Final Environmental Impact Statement (FEIS)
Chapter 343, Hawaii Revised Statutes (HRS)

LUINAKOA PARTNERS
RESIDENTIAL SUBDIVISION
JANUARY, 1993

DOCKET NO. A92-678
WILLIAM CROWDER

FINDINGS OF FACT, CONCLUSIONS OF LAW, AND DECISION AND ORDER
ACCEPTING A FINAL ENVIRONMENTAL IMPACT STATEMENT FOR A
STATE LAND USE DISTRICT BOUNDARY AMENDMENT

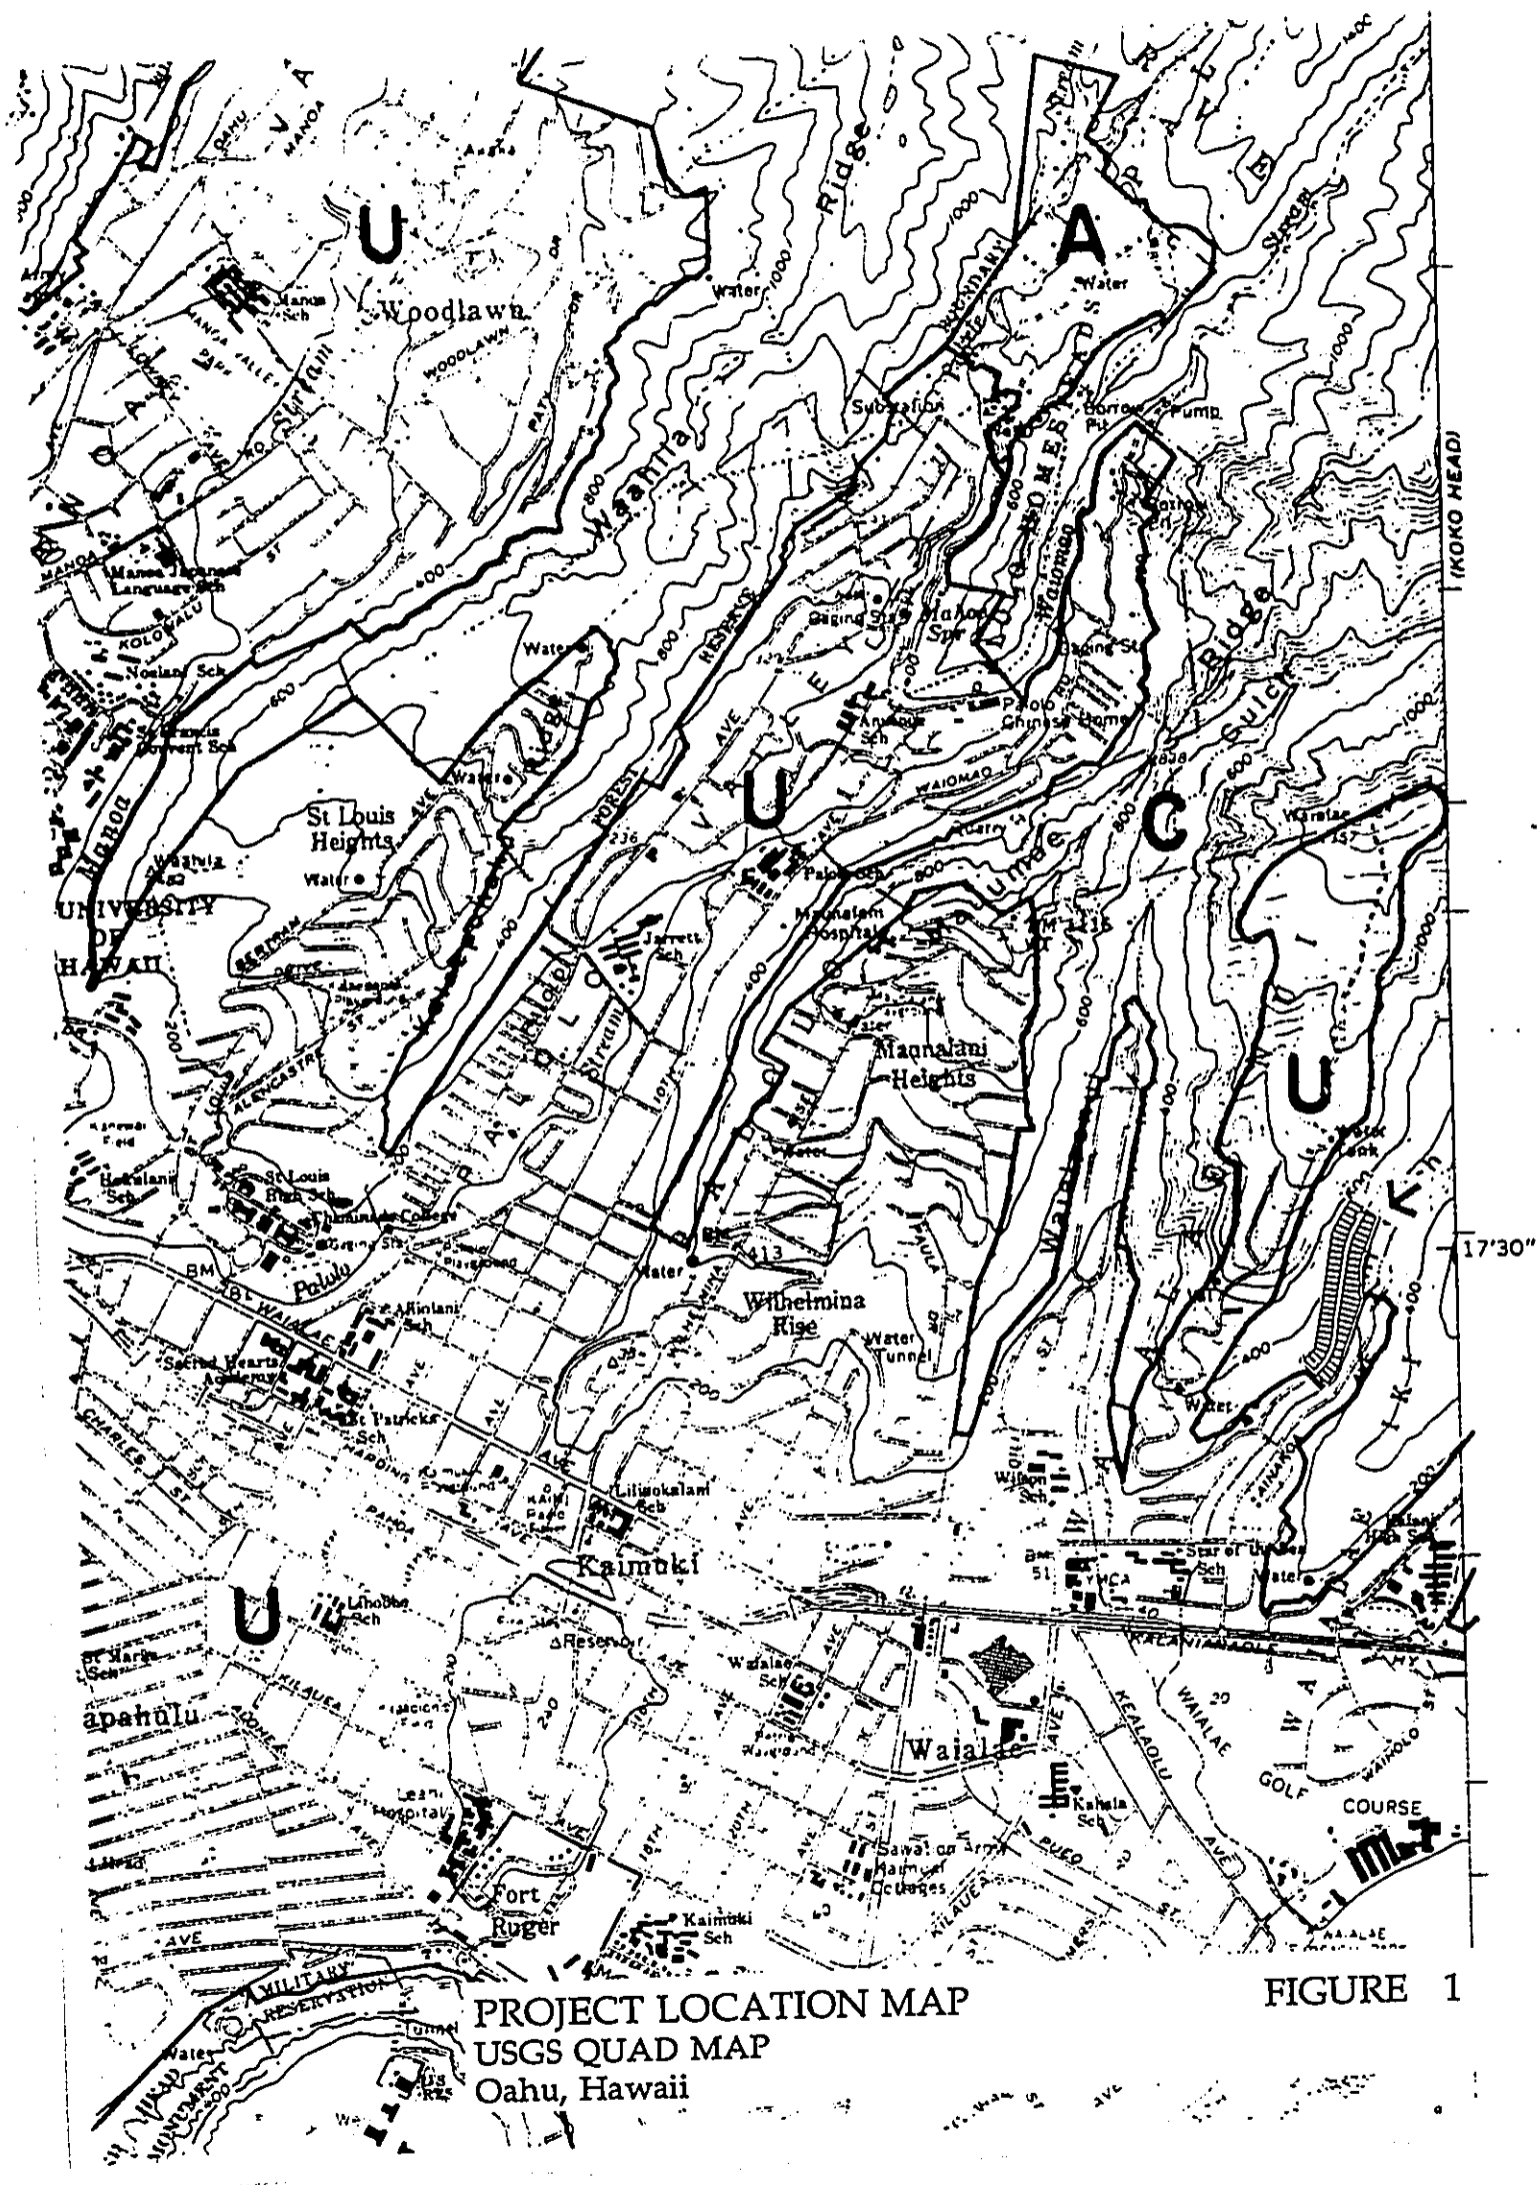
9) The proposed project site should also be depicted on a copy of the State Land Use District Boundary Map for the area. We suggest that Figure 1 be amended to show current district boundaries.

The suggested locations for the siren are annotated in red on the enclosed section of the USGS QUAD MAP, Oahu, Hawaii.

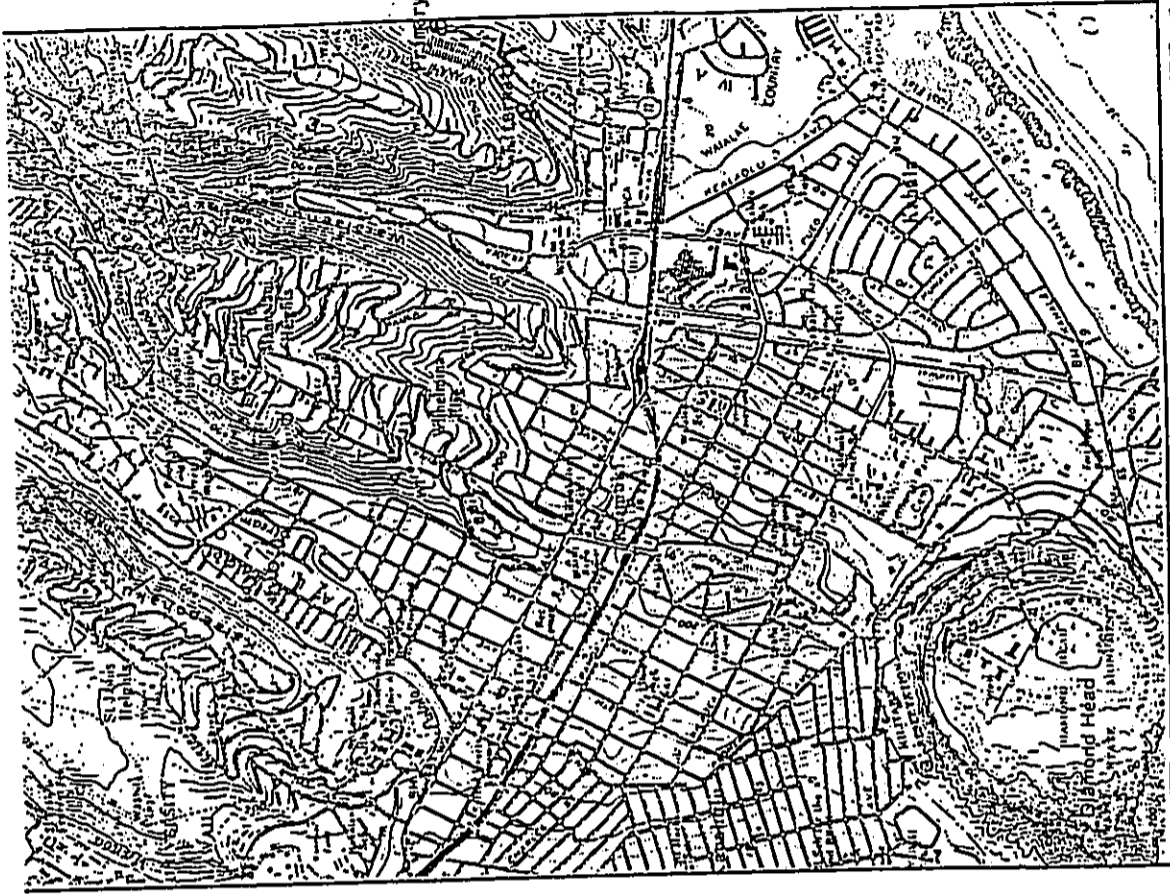
We do not have negative comments specifically directed at this draft environmental impact statement. However, the proposed subdivision is located in an area not covered by an existing warning device (siren). As such, we do have a proposal that an electronic solar powered siren be installed to help alert residents of an impending or actual event that threatens the subdivision. This siren must have a minimum output of 1150B and be compatible with the existing civil defense siren system. The proposed siren requires a 100-foot radius buffer zone in which there is no residential building. There are two suggested locations adjacent to the project which meet this criteria:

The State and Bishop Estate are developing a water source in located Kapakahi Gulch (Ainakoa) at the end of Ainakoa Avenue. If this location is developed as a water source, it could serve as the primary siren site. An alternate location is the existing water tank compound located at Luinakoa and Halekoa Drive.
